UNITED STATES PATENT AND TRADEMARK OFFICE

APPLICATION NO.	FILING DATE	FIRST NAMED INVENTOR	ATTORNEY DOCKET NO.	CONFIRMATION NO.
09/476,521	01/03/2000	Herbert Gropp	RUM212	7964

Office Action Summary

1. The request filed on March 29, 2002 for a Continued Prosecution Application (CPA) under 37 CFR 1.53(d) based on parent Application No. 09/476,521 is acceptable and a CPA has been established. An action on the CPA follows.

Fig. 1

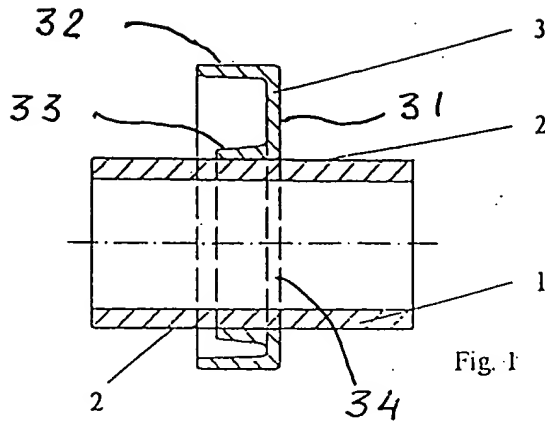
(C) The corrected Fig. 1 has been approved.

(a) the drawings should show the plane upon which a sectional view such as Fig. 1 is taken; and

(A) the insertion in line 9 on page 6 of the specification. The original disclosure does not convey the concept that the cam 3 shown in Fig. 1 has an opening diameter slightly smaller than an outer pipe diameter, thus, it is new matter. *In re Anderson, supra*;

Fig. 2

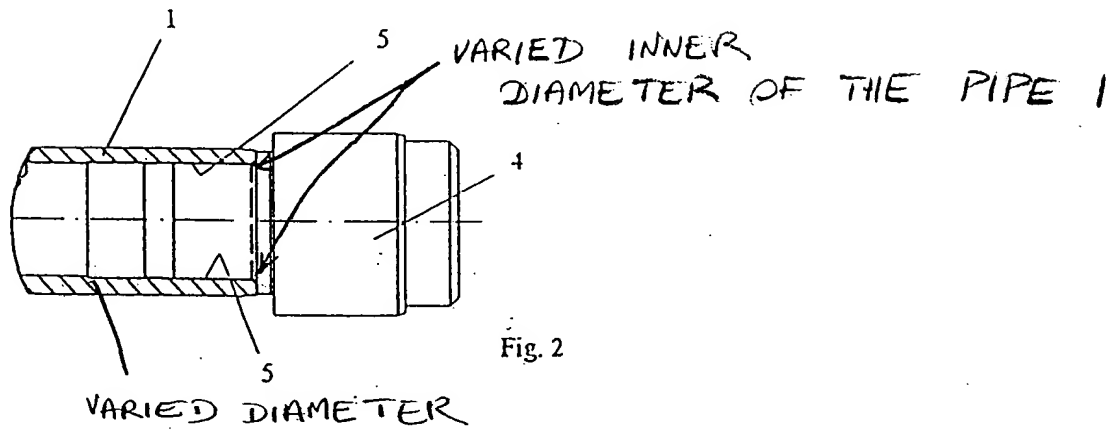
(a) new Fig. 4 introduces new matter such as the end piece 4 as now shown. The original Fig. 2 shows that the inner diameter of the pipe 1 is varied: (1) at the junction of the end piece 4 and the pipe 1 as shown by applicant's phantom line; and (2) at referential numeral 1 (see attached Exhibit). However, Fig. 4 shows that the inner diameter of the pipe 1 is constant. The

Not
Approved
VL
10/20/00

Fig. 3

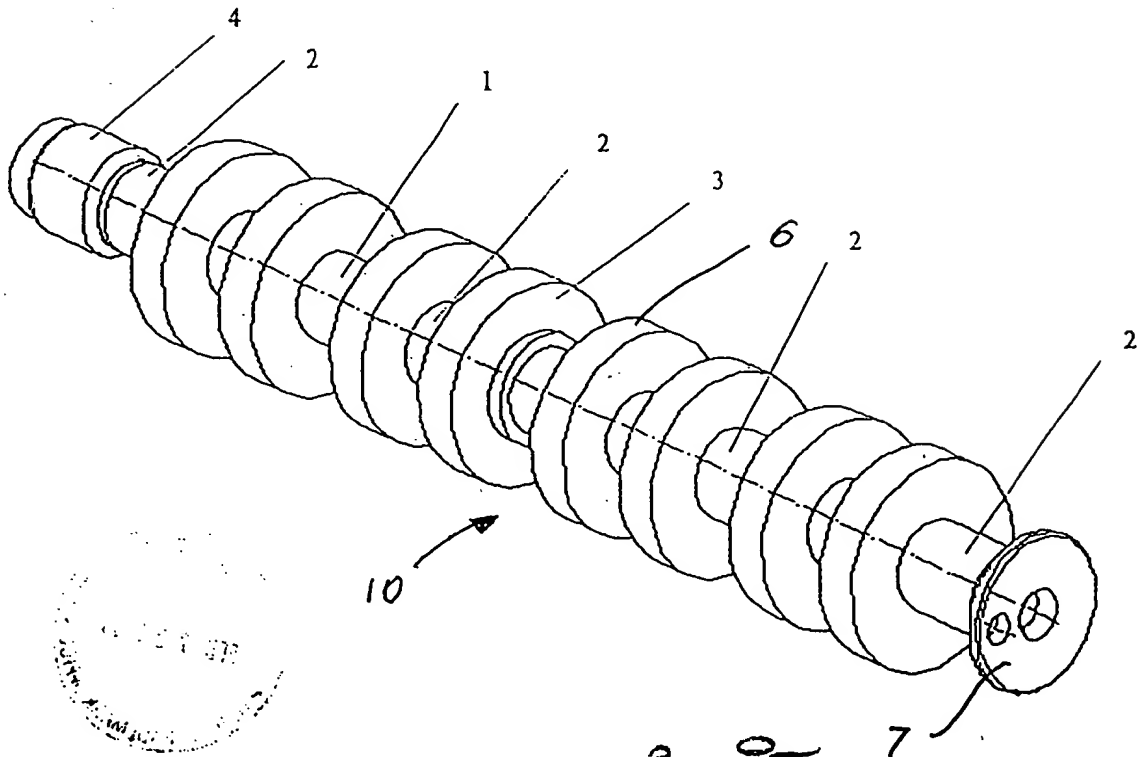
(B) The corrected Fig. 3 has been disapproved since it introduces new matter. The original drawings do not show the bearing rings. The corrected Fig. 3 now shows the bearing 6 which is identical to the cam 3. The showing and description of a specific type of bearing within a full spectrum of possible bearings is considered under the present disclosure to be new matter. *Cf.*, *In re Smith*, 173 U.S.P.Q. 679 (CCPA 1972) and *Ex parte George*, 230 U.S.P.Q. 575, 578 (Bd. Pat. App. & Inter. 1986).

(b) the orientation of the cams 3 as now shown in Figs. 11 and 18 is unsupported by the record as filed. In fact, the original Fig. 3 shows that the cams 3 are oriented in the same direction. However, new Figs. 11 and 18 show that the cams 3 are oriented in different directions (some are pointed to the left and some are pointed to the right). The different orientations of the cams 3 introduce new matter; and

Disapproved
VL
10/20/00

Fig. 4

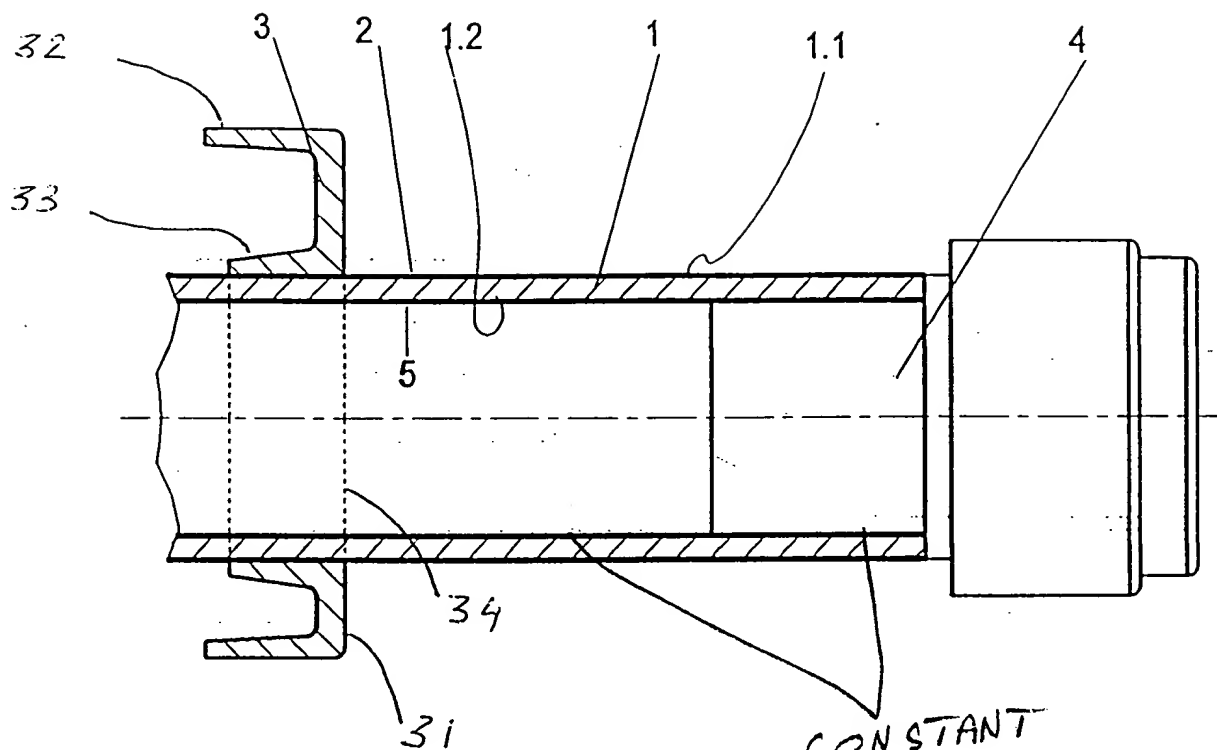
(A) New Fig. 4 has been disapproved because:

original disclosure does not convey the concept that the inner diameter of the pipe 1 is constant, thus, it is unsupported by the record as filed. *In re Anderson*, 176 U.S.P.Q. 331 (CCPA 1973); and

(b) new Fig. 4 is inconsistent with the description in Paper No. 9. The insertion on page 6, line 12 of the specification, states that the outer diameter of the end piece 4 is slightly larger than an inner diameter of the pipe 1. However, Fig. 4 shows that the outer diameter of the end piece 4 is equal to the inner diameter of the pipe 1.

CONSTANT
DIAMETER
(NEW MATTER)
